Merged Document Report

Description :	
Address :	650 OSAGE CORPUS CHRISTI TX 78405
Record Type :

PLAT OF TGH TWO

A REPLAT OF LOZANO ELEMENTARY SCHOOL TRACT, BLOCK
1, LOT 1, AS SHOWN ON A MAP RECORDED IN VOLUME 53,
PAGE 7, MAP RECORDS NUECES COUNTY, TEXAS.

PLAT OF TGH TWO

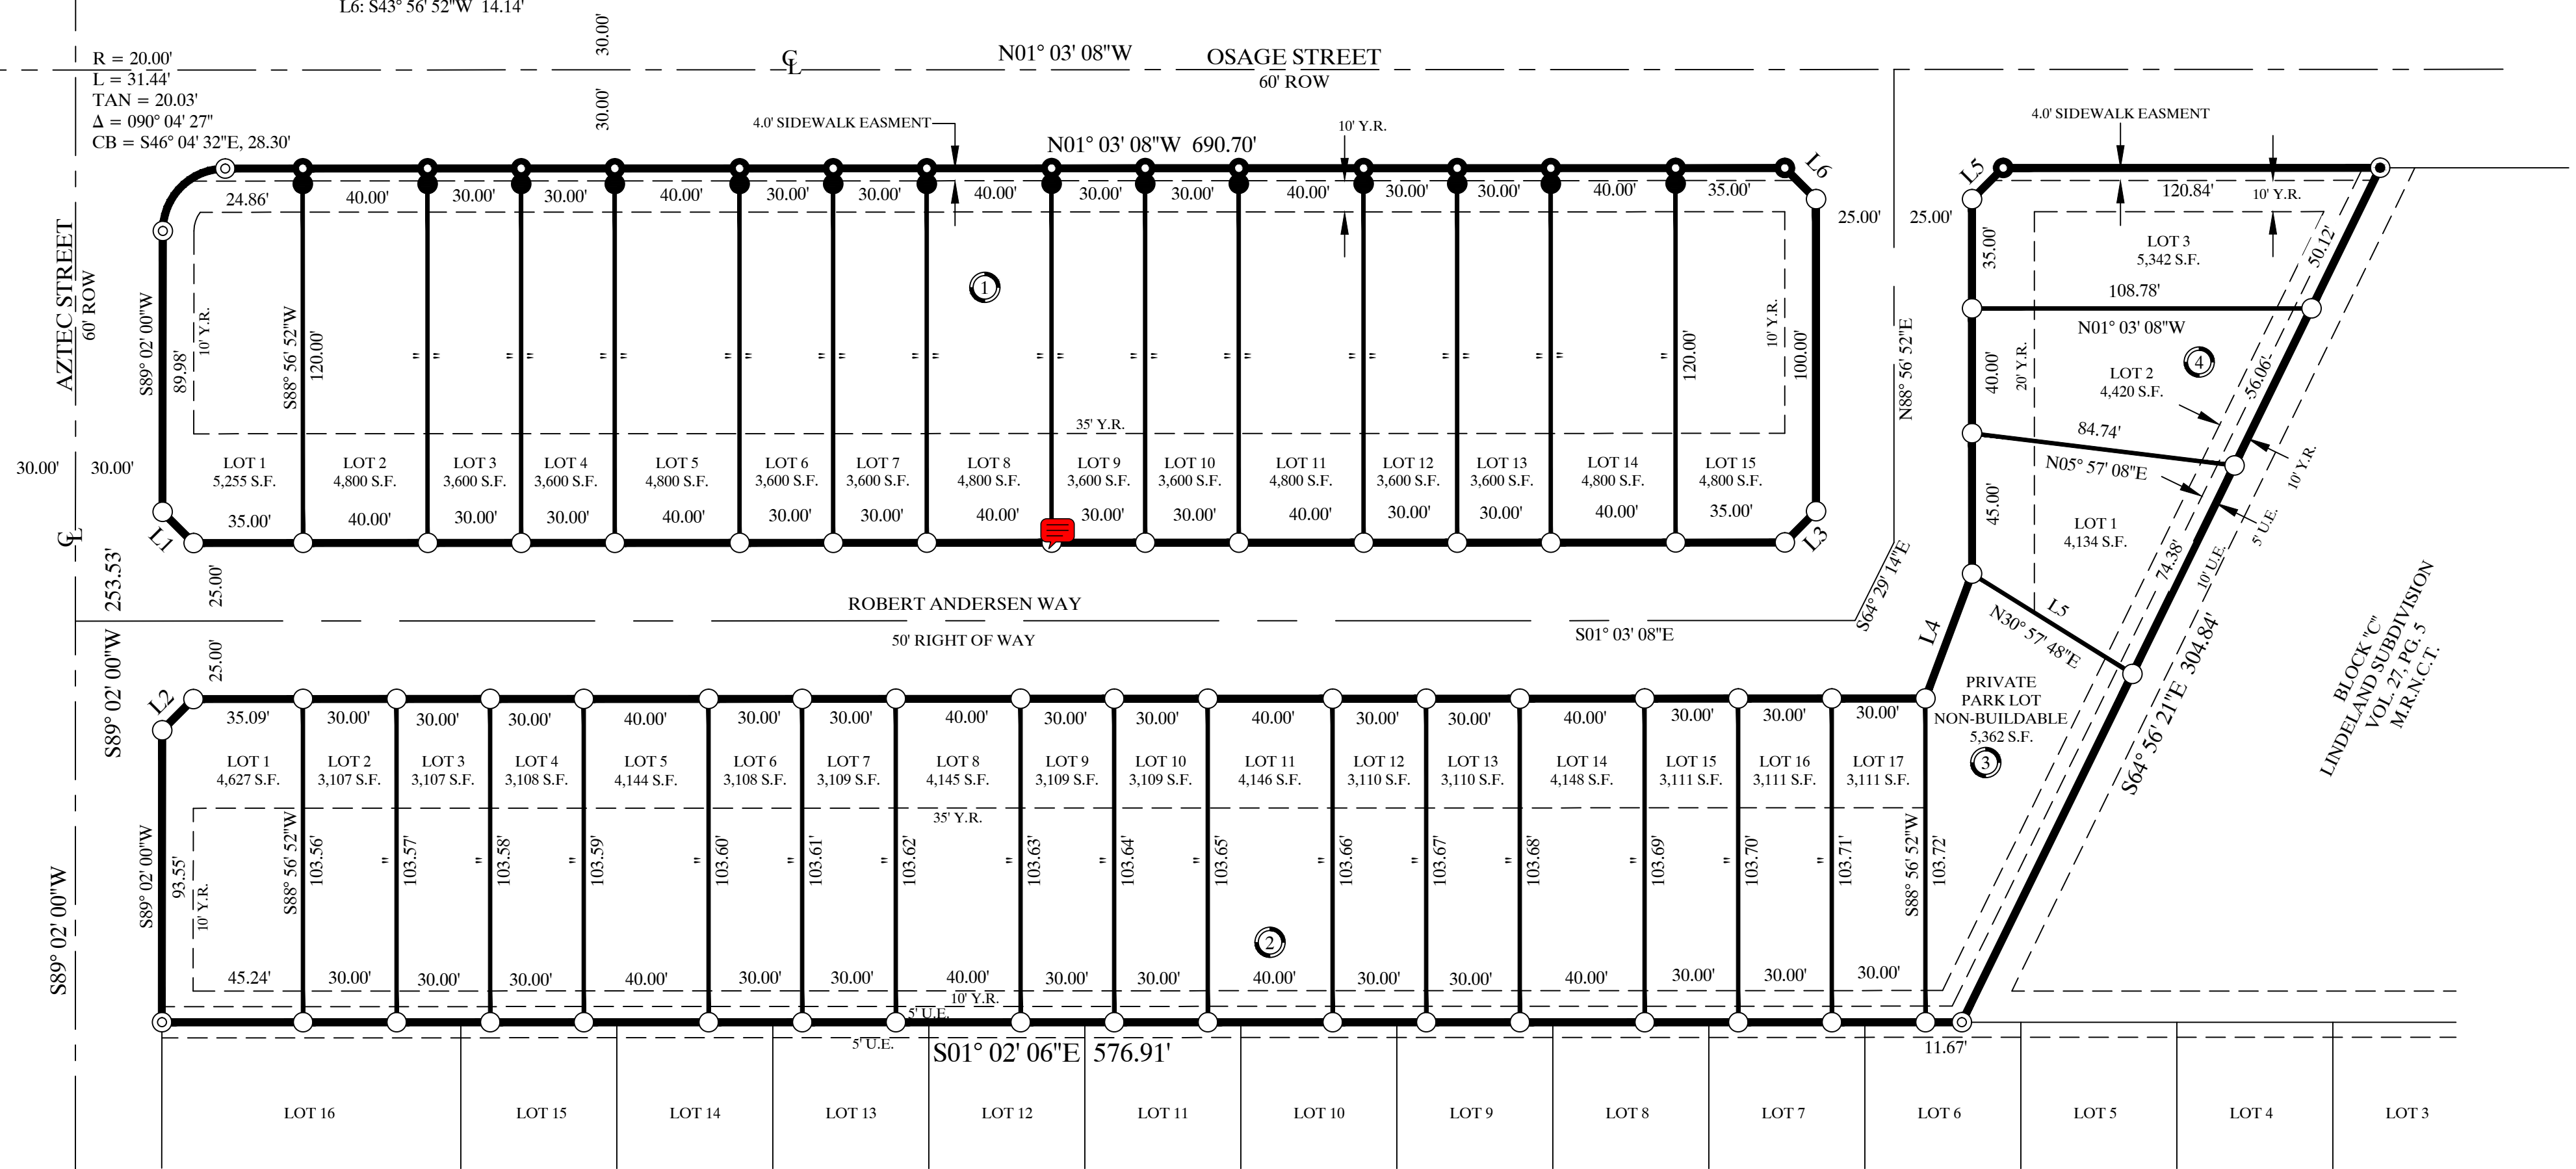
Comment ID	Page Reference	Annotation Type	Author : Department	Status	Review Comments	Applicant Response Comments
1	Page1	Callout	Mark Zans : DS	Closed	Change chairman name to Michael Miller	
1	Page1	Callout	Mark Zans : DS	Closed	Change chairman name to Michael Miller	
3	Page1	Note	Mark Zans : DS	Closed	Planning comment: Add P.U.D. to plat title	
3	Page1	Note	Mark Zans : DS	Closed	Planning comment: Add P.U.D. to plat title	
5	Page1	Note	Mark Zans : DS	Closed	Planning comment: Provide a copy of the HOA documents if available for review.	
5	Page1	Note	Mark Zans : DS	Closed	Planning comment: Provide a copy of the HOA documents if available for review.	
11	Page1	Note	Mark Zans : DS	Closed	Park & Rec. comment; 1. Park & Rec. has no responsibility for private park. Place a general note on the plat stating such. 2. Park Development Fee: 35 units x 462.50 = \$16,187.50	
11	Page1	Note	Mark Zans : DS	Closed	Park & Rec. comment; 1. Park & Rec. has no responsibility for private park. Place a general note on the plat stating such. 2. Park Development Fee: 35 units x 462.50 = \$16,187.50

19	Page1	Note	Mark Zans : DS	Closed	Place a note on the plat stating no lot shall have a driveway access to Osage St. or Aztec St.	
19	Page1	Note	Mark Zans : DS	Closed	Place a note on the plat stating no lot shall have a driveway access to Osage St. or Aztec St.

Change chairman name to Michael Miller

PLAT OF TGH TWO PUD

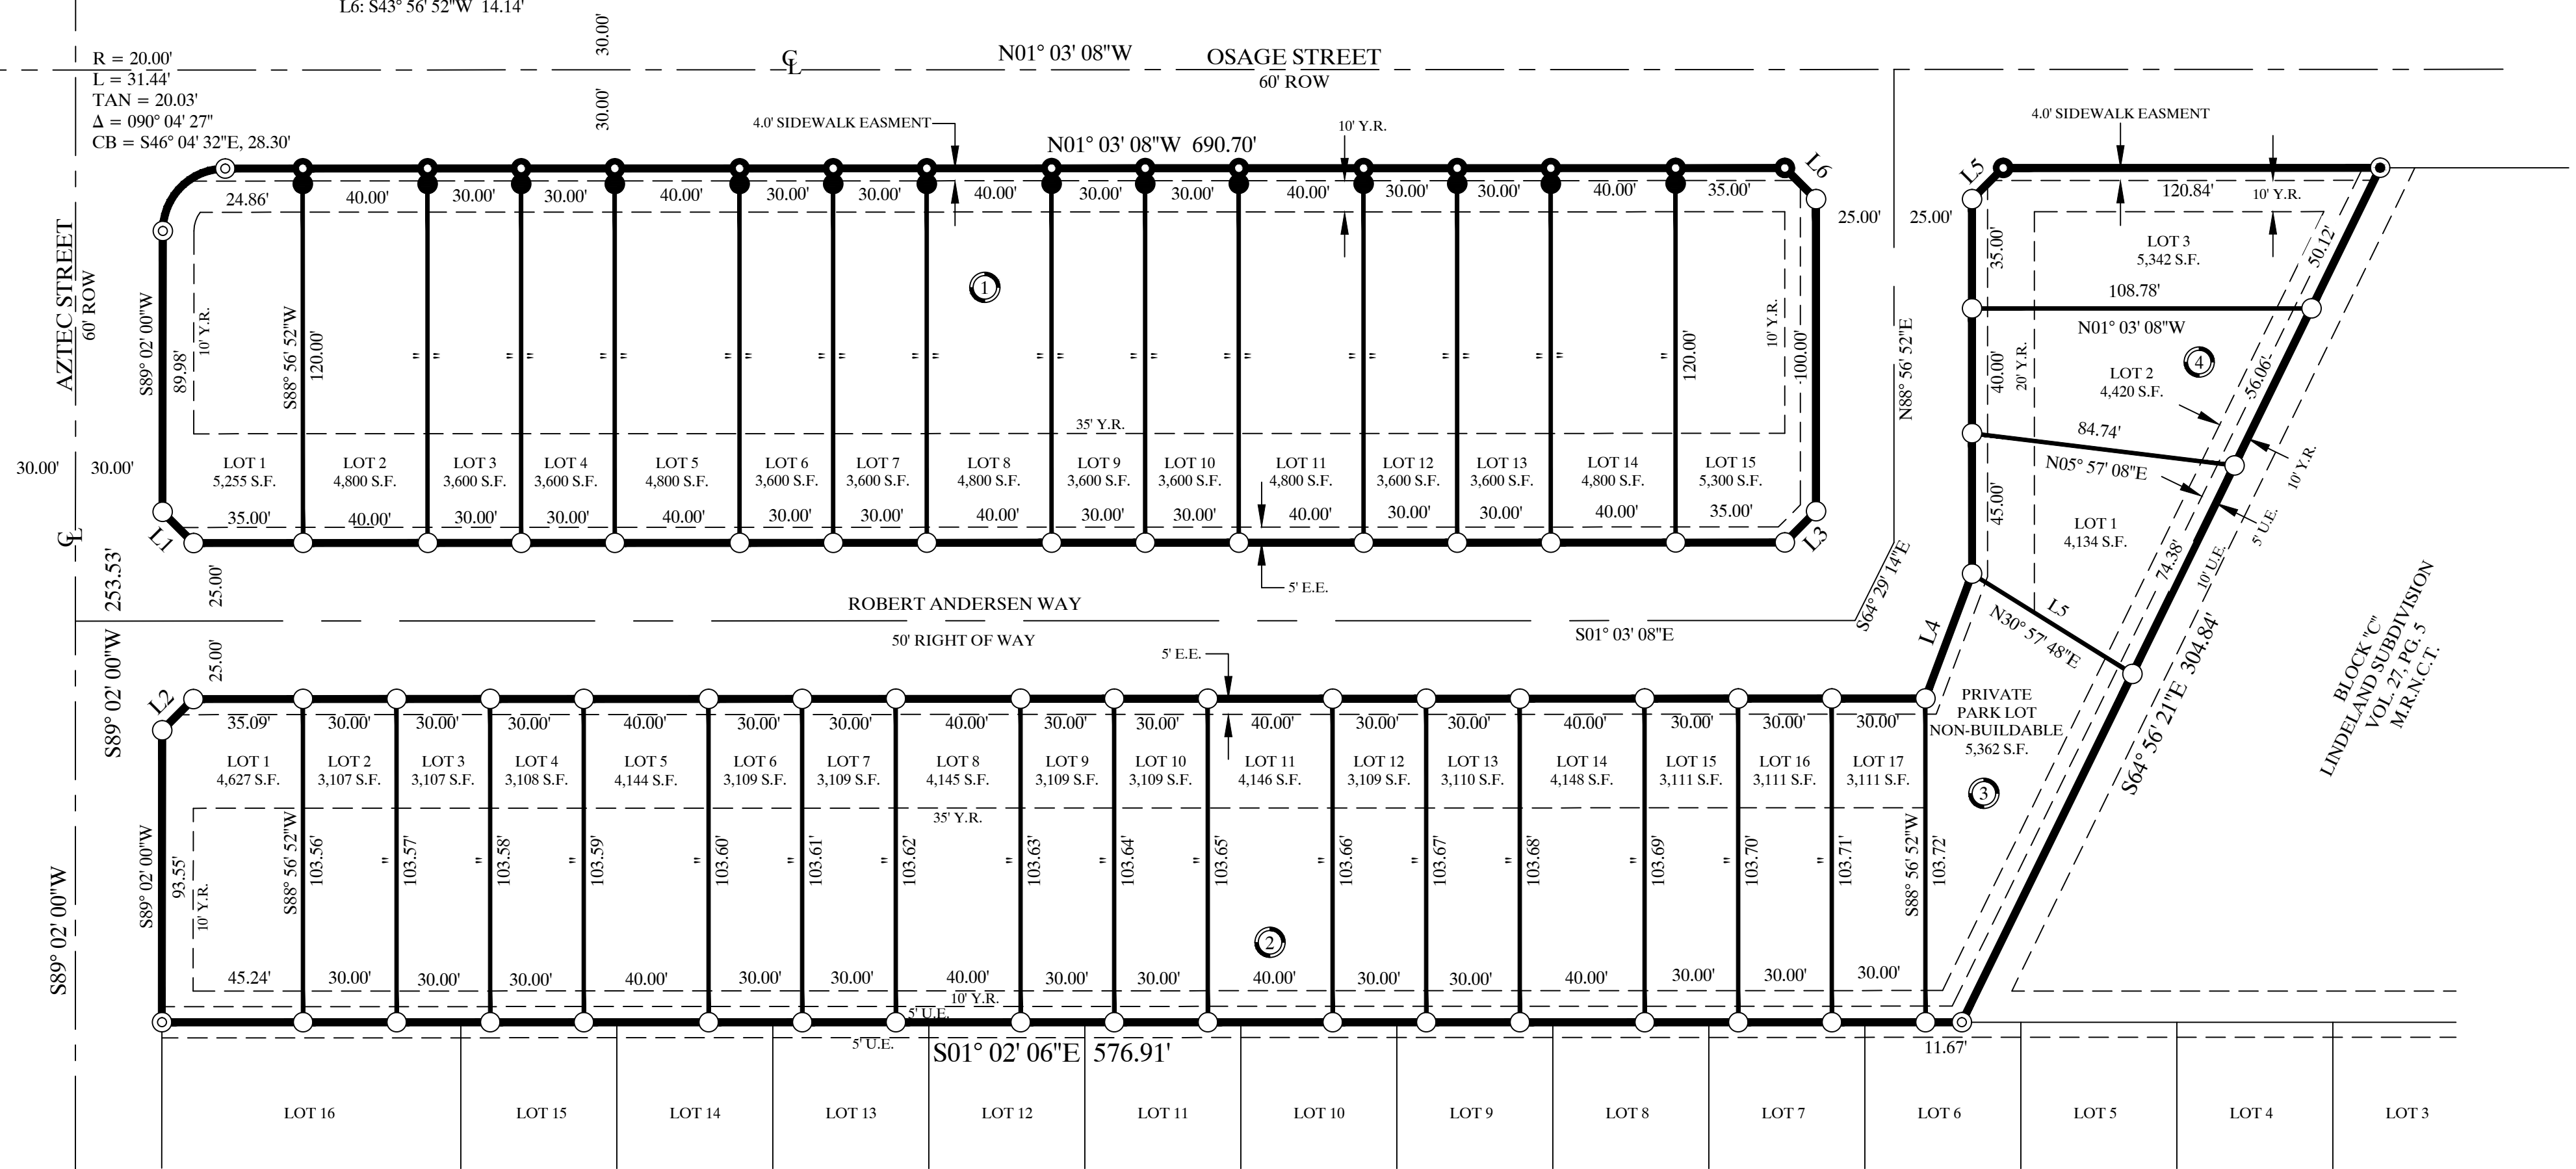
19	Page1	Note	Mark Zans : DS	Open	Place a note on the plat stating no lot shall have a driveway access to Osage St. or Aztec St.	
4	Page 2	Note	Mark Zans : DS	Open	Planning comment: Add P.U.D. to plat title.	
9	Page 2	Note	Mark Zans : DS	Open	Planning comment- AEP Distribution is requesting 5' E/E along the ROW of internal street.

Change chairman name to Michael Miller

7. PARK LOT TO BE MAINTAINED BY HOMEOWNER'S ASSOCIATION.
8. NO LOT SHALL HAVE A DRIVEWAY ACCESS TO OSAGE ST. OR AZTEC ST.

MICHAEL MILLER
CHAIRMAN
